# CITY OF ALBUQUERQUE

**RE: Smith's #423 Fuel Center  
Grading and Drainage Plan (Stamp Date 11/16/2015)  
Hydrology File: F14D072**

Based upon the information provided in your submittal received 11-18-2015, the above-referenced plan cannot be approved for Building Permit until the following items are addressed:

**Utility Plan**  
**Smith's #423 Fuel Center**  
5640 4th Street N.W.  
Albuquerque, New Mexico 87107

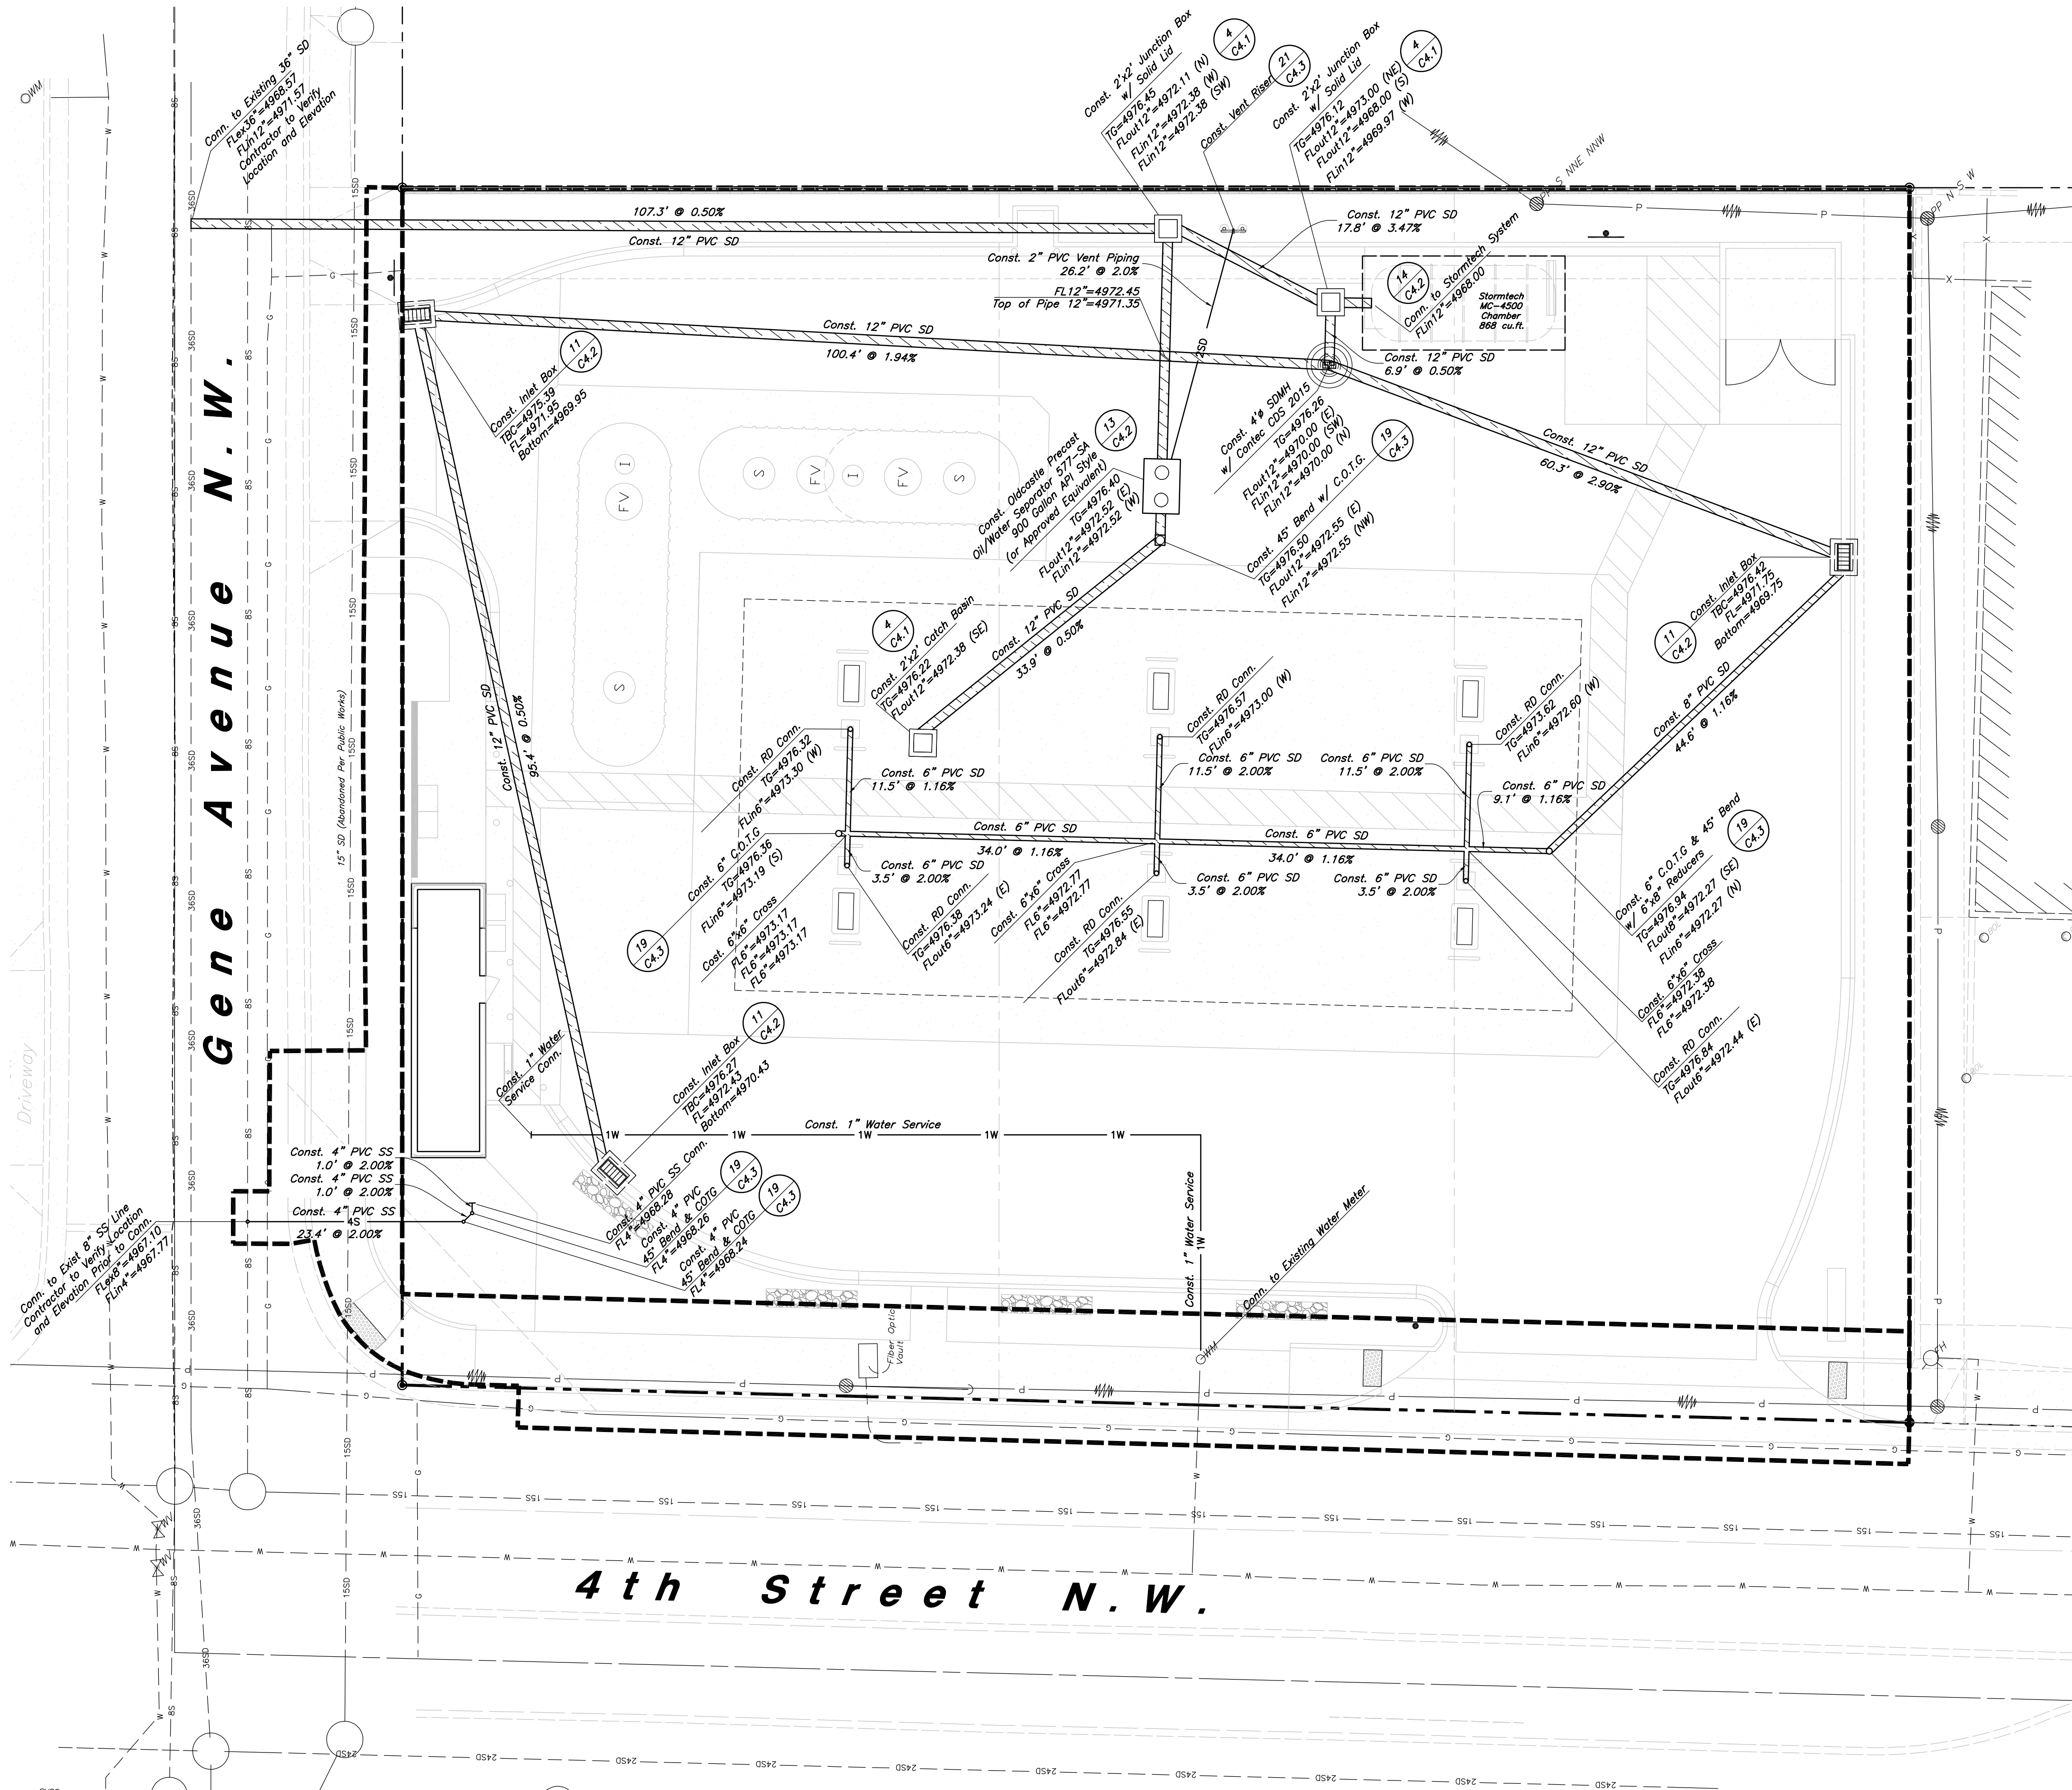
1. The segment of the drain pipe that is in the right of way will need to be completed through Work Order; it can be included in the DRC set that is referenced on the plan.

- a. The connection to the 36" storm drain cannot be direct; a manhole needs to be constructed (to City standards).
  - b. The City does not allow PVC pipe for storm drain in the right of way, you would need to transition to RCP, or HPPP (High Performance Polypropylene Pipe).

- c. For your reference, the DRC set will need to show that the gas line and other utilities do not conflict with the new pipe under Gene Avenue.
2. A detail for a Snout is shown, but the reference on the plan for an oil/water separator is a Contech CDS. Where is the snout being used? If you do use the snout, show the approx. sump elevation and the approx. outlet elevation.
